A D D E N D U M N O . 1

MAGNOLIA BEACH FIRE STATION PROJECT

CALHOUN COUNTY, TX

March 12, 2026

3 SOUTH ELEVATION
 A1.7 SCALE : 3/16" = 1'-0" LOOKING NORTH

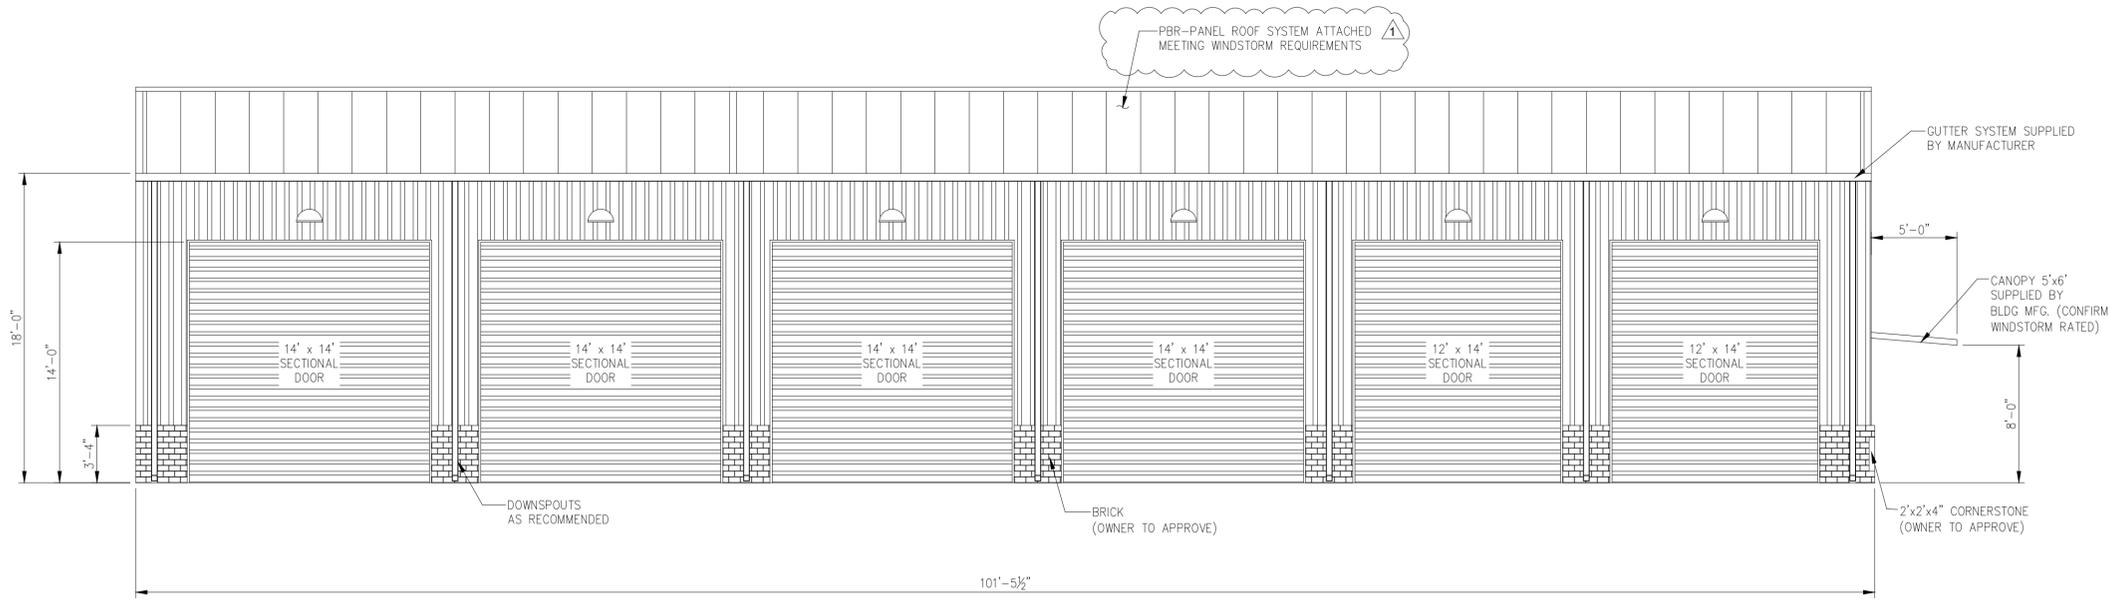
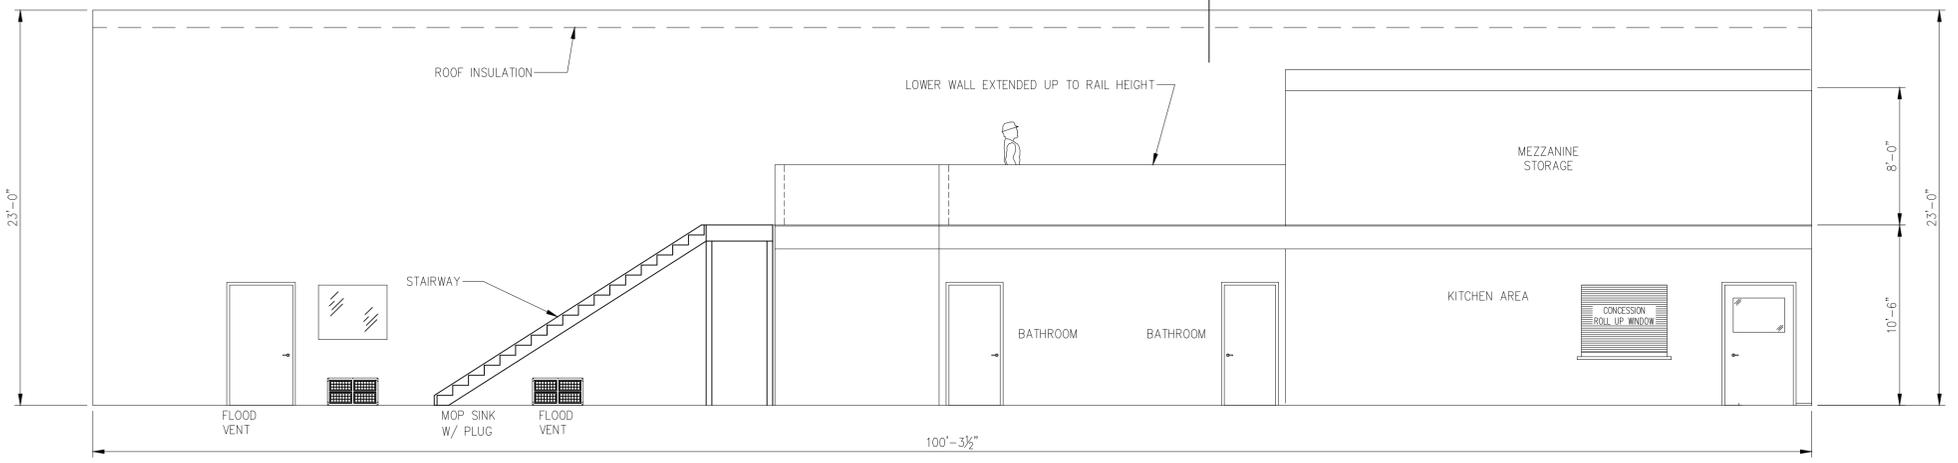
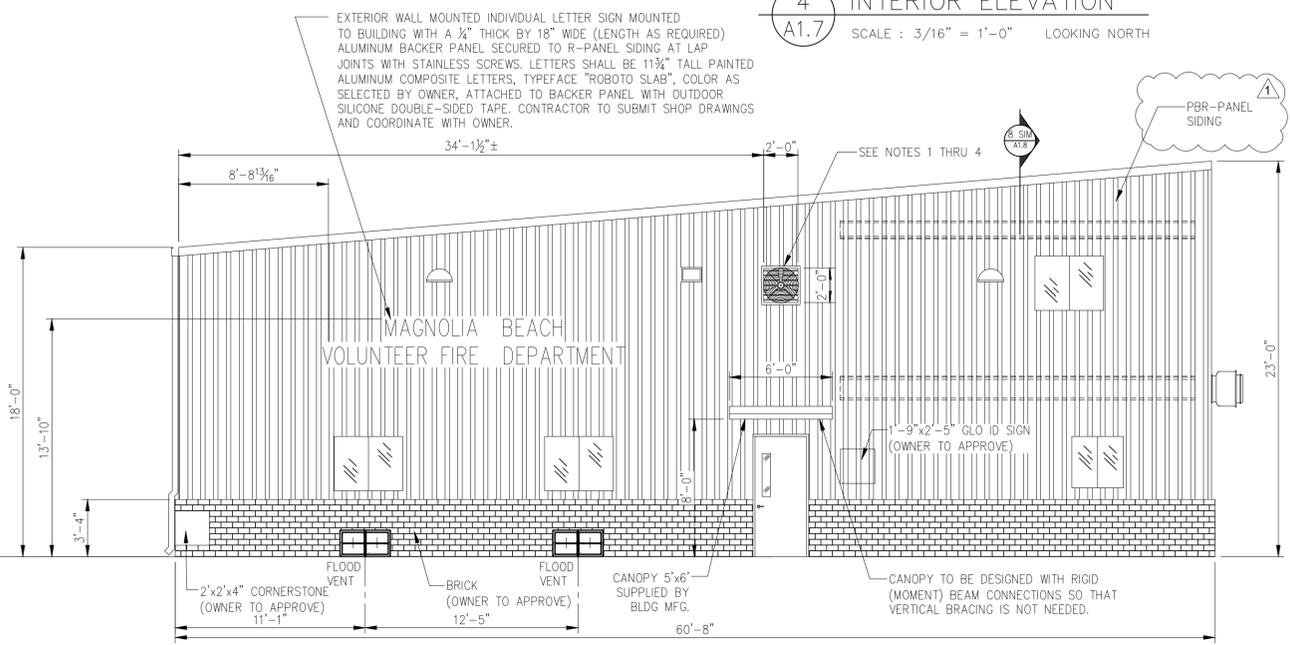
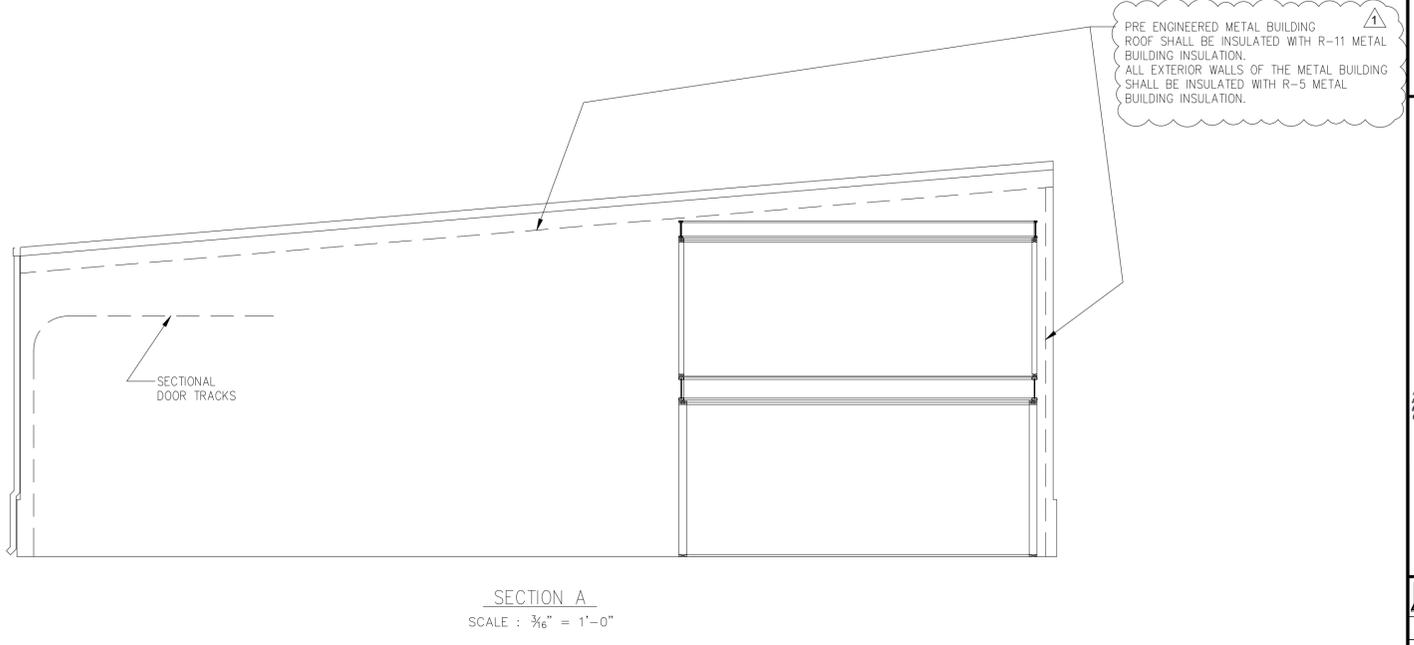
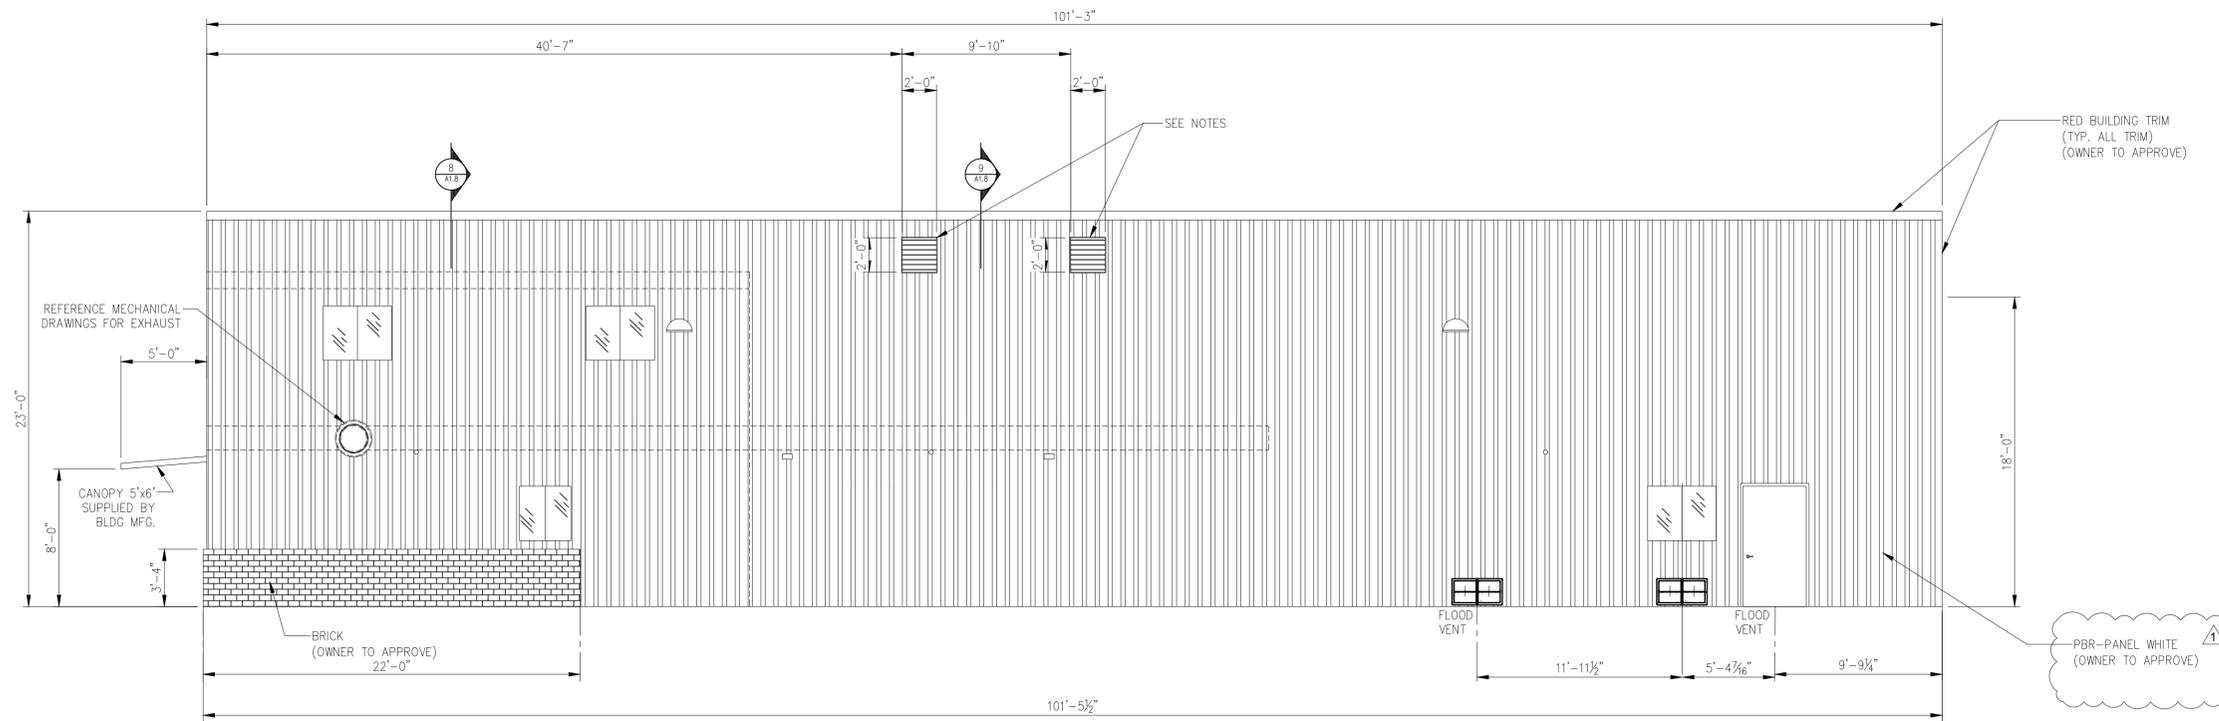
EXPLANATION: C9.2 – Corrected Notes, Table and Detail 9.
S1.0 – Corrected dimensions and revised/added notes.
S1.1 – Corrected dimensions and added note.
A1.1 – Revised General Notes
A1.2 – Revised Door “D” note.
A1.3 – Revised Insulation Notes
A1.4 - Added note for blind requirements.
A1.7 – Modified Notes and updated call outs.
A1.8 – Modified Notes and updated call outs.
A1.9 – Updated call outs.

Please provide clarification on who is to supply and install the Global Industrial fan and louver that is shown on A1.7. (Notes 1-4) Please provide clarification on who is to supply and install the Condenser stand shown in the electrical drawings. Please provide clarification on who is to supply and install the HVLS fans.

Answer: The statement "mounting to be furnished and installed by this contractor" is intended to mean that the type of mounting, structural reinforcement, anchoring and fastener requirements are to be provided by contractor in the shop drawing and submittal phase. It will be required that the supplier ensure that the systems are designed appropriately for the wind loads required of the project. The contracted contractor is required to procure/supply the equipment and then install the same to meet windstorm requirements. The condenser stand is to be built and installed by the contracted contractor. The HVLS fans are to be procured/supplied by the contracted contractor.
